Access Compliance Report

Public Rights-of-Way

Intersection ID: 9982	Main Street: E_36TH_ST	Cross Street: N_DAVIDSON_ST	Location: E
ADA ID: E680355796FA	Ramp Type: PerpDiag	Initial Pass/Fail: Fail	Overall Compliance: No
Severity Score: 26.25			
Codes/Mitigation Info/Possible Solution		Field Measurements/Component Compliance

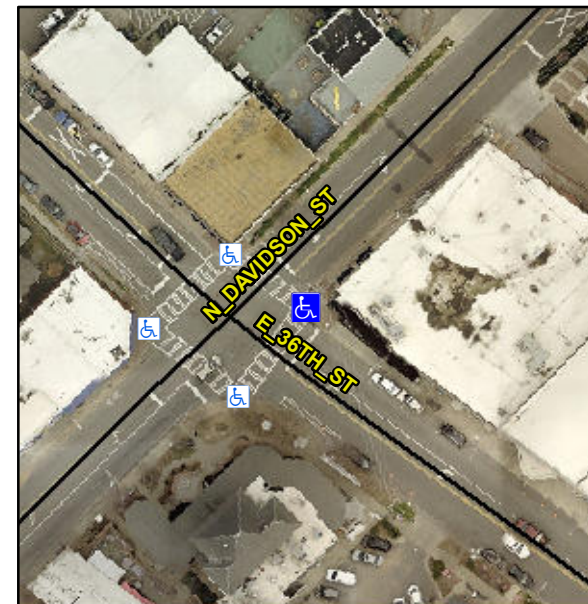
Not Found, R304.2.2, R304.5.3

Compliance	Description	Data	Compliance	Description	Data
N/A	Ramp Length (in)	80.0	No	Ramp Slope (%)	13.6
Yes	Ramp Width (in)	48.0	No	Ramp XSlope (%)	4.9
N/A	Flare Type LT	N/A	N/A	Flare Type RT	N/A
N/A	Flare Slope LT (%)	N/A	N/A	Flare Slope RT (%)	N/A
N/A	Flare Traversable LT?	N/A	N/A	Flare Traversable RT?	N/A
N/A	Landing Length (in)	N/A	N/A	DWS Provided?	N/A
N/A	Landing Width (in)	N/A	N/A	DWS Contrast?	N/A
N/A	Landing Slope (%)	N/A	N/A	DWS Length (in)	N/A
N/A	Landing X Slope (%)	N/A	N/A	DWS Full Width?	N/A
N/A	Landing Curb? (Y/N)	N/A	N/A	DWS Offset (in)	N/A
N/A	Shared Landing?	N/A			
N/A	Gutter Ponding?	N/A	N/A	Gutter Slope (%)	N/A
N/A	Gutter Lip Ht (in)	1.0	N/A	Gutter X Slope (%)	N/A
N/A	Painted X Walk1?	Yes	N/A	Painted X Walk2?	Yes
	X Walk 1 Direction	To NW		X Walk 2 Direction	To SW
N/A	X Walk 1 Width (in)	103.0	N/A	X Walk 2 Width (in)	106.0
	X Walk 1 Slope (%)	0.3		X Walk 2 Slope (%)	5.3
	X Walk 1 X Slope (%)	3.2		X Walk 2 X Slope (%)	0.3

N/A	Ramp inside XWalk1?	Yes	N/A	Ramp inside XWalk2?	Yes
	Road Slope (%)	4.0	N/A	Clear Space?	N/A
	Road X Slope (%)	3.7	N/A	Clear Space to XWalk (in)	N/A
N/A	Any Obstructions?	N/A	N/A	Storm Grate/Utility Hazard?	N/A
	Obstruction Type			Storm Grate/Utility Type	
		N/A			N/A
		Yes		Surface Condition? (G/P)	Good

Remove & Replace Curb Ramp With Two New Directional Ramps or Equivalent.
